County of Fairfax, Virginia

Re: Interpretation for SP 79-D-054-1, Chesterbrook Swim and Tennis Club, 1812 Kirby Road,
Tax Map 31-3 ((5)) 1, 1A, 31-3 ((1)) 60B: Covered Decks and Sheds

CHESTERBROOK SWIM & TENNIS CLUB
POOL HOUSE RENOVATION

Architectural Site Plan

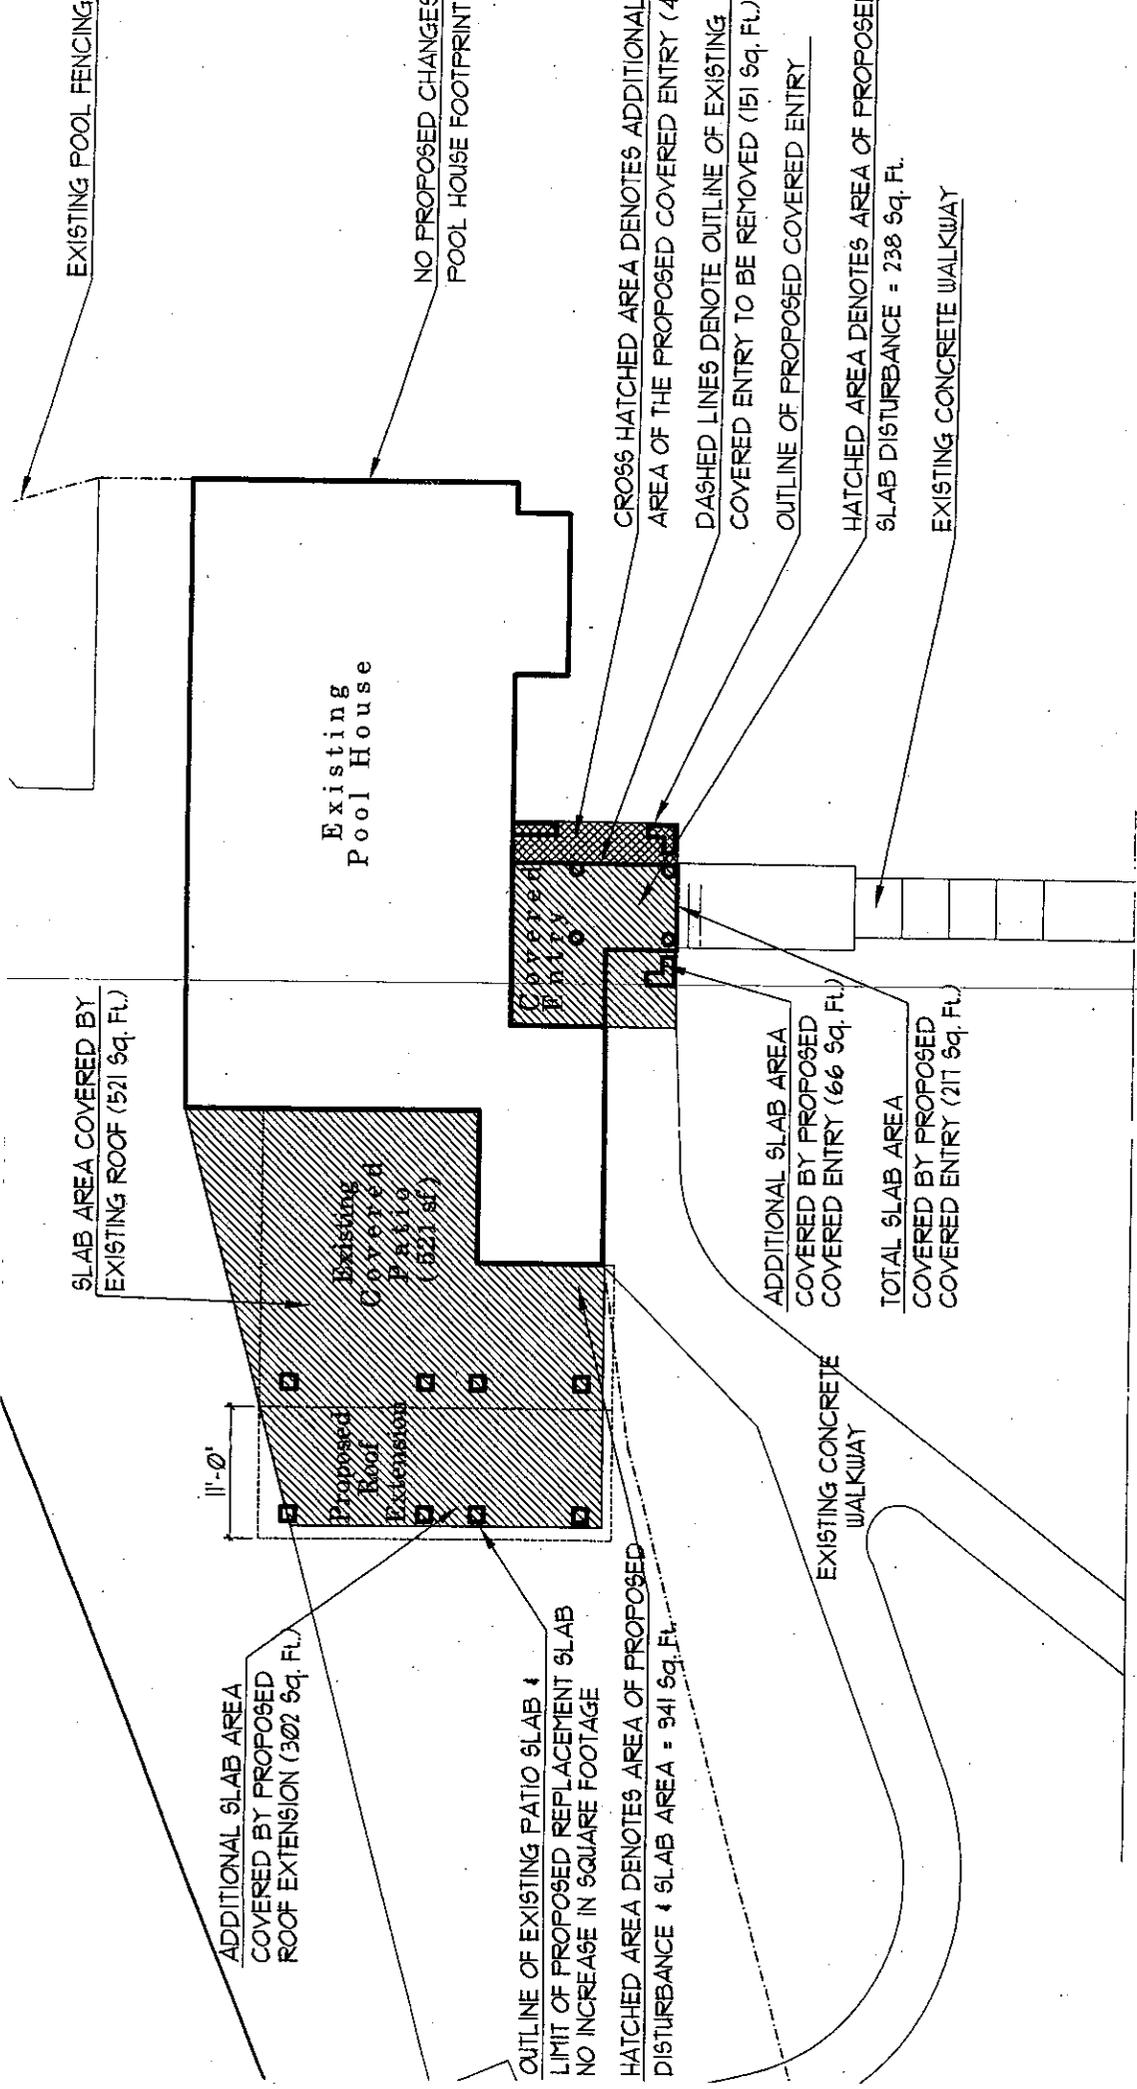
According to your letter and e-mails, you are proposing to add two covered decks. You have stated, and have shown with the photos, that only existing covered deck and patio areas will be used and that no additional clearing or impervious surface will be necessary to add the proposed decks. The first proposal is to remove the existing covered deck at the front entrance of the pool

house. You propose to replace it with a new covered deck measuring 14' x 17', or a total of approximately 217 square feet, with a roof height of 15'. The new covered deck entrance is proposed to be wider than the existing covered deck entrance and to provide a bench for 6 people.

Your second proposal is to add to the existing covered deck on the west side of the pool house. The existing deck was built without permits or a prior request for substantial conformance. The existing covered deck measures 18' x 25', for a total of approximately 521 square feet, with a height of 15'. The proposed covered roof area is 10' x 30', for a total of approximately 302 square feet. The existing and proposed covered deck areas will be open on three sides and consist of an overall total of approximately 823 square feet.

It is my determination that the two proposed covered decks, the existing covered deck and the two existing sheds are in substantial conformance with the SPA Plat and development conditions. This determination has been made in my capacity as the duly authorized agent of the Zoning Administrator. Please note that a building permit is required for the proposed construction. You may contact Zoning Permit Review Branch at 703-222-1082.

Rear view of Patio Roof

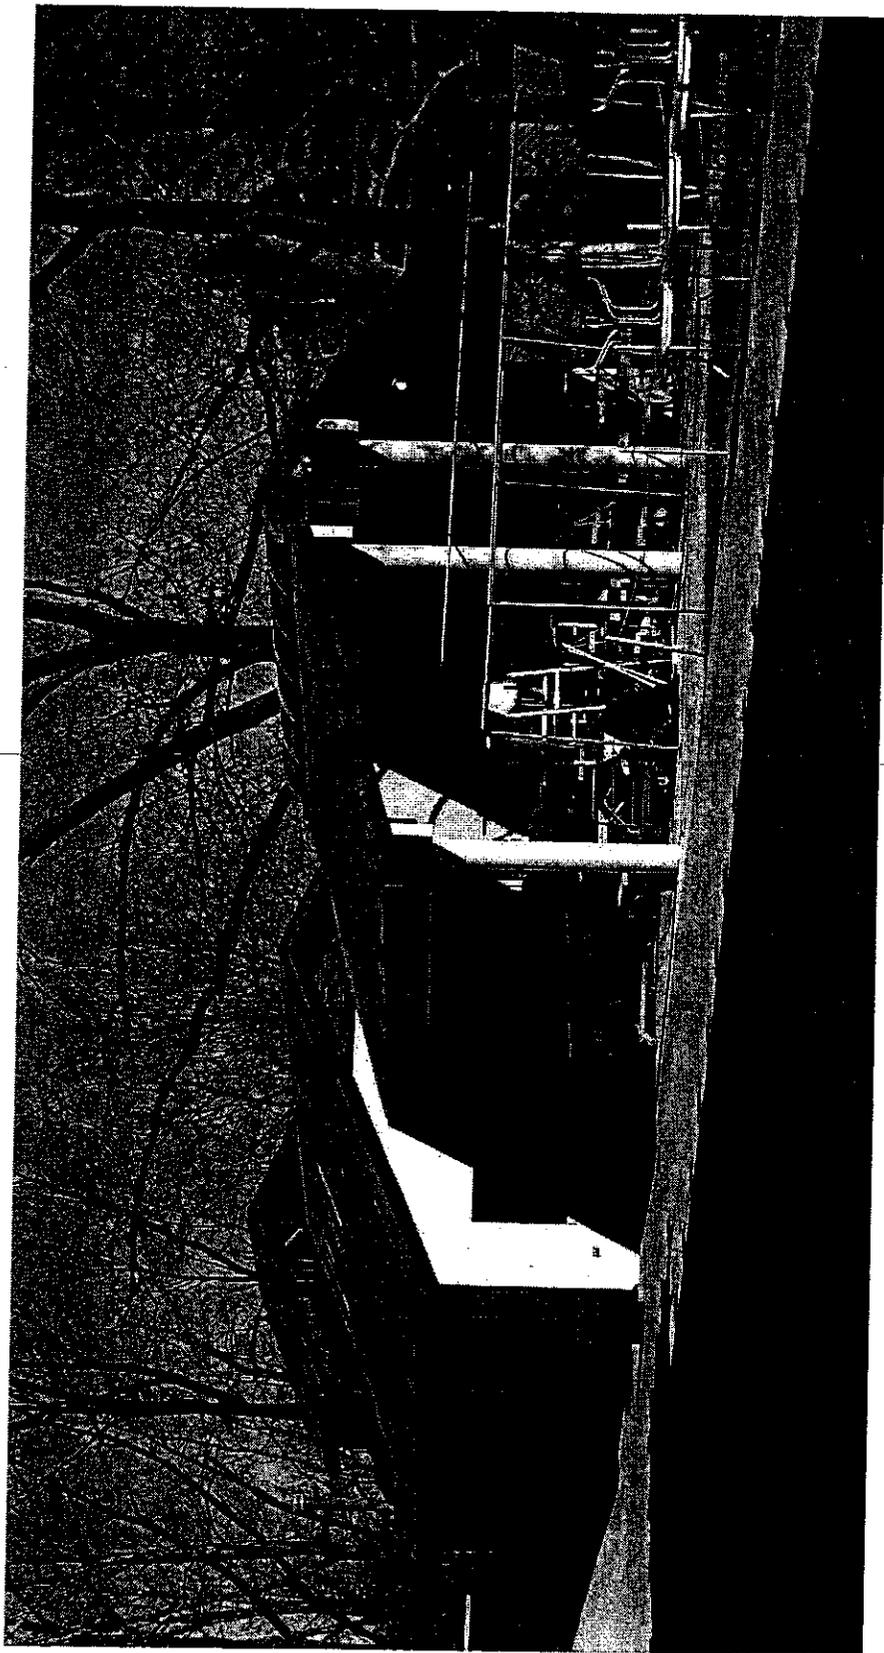
In 1985 the Club constructed the patio roof, as spoken off above. The Club is and will remain respectful of the County's due process procedures. Unfortunately, neither the Club nor the County can find a building permit or an authorization for this work. There is a reference in our tax assessment that mentions the date 1985 which we confirmed from our former Club Manager. It is his recollection that the patio roof was added in 1985 and he remembers County personnel inspecting the construction. Nonetheless, no other records or approvals for the construction can be found.

As this roof extension has been in existence for 26 years, we would request that the County approve this construction change in our overall request.
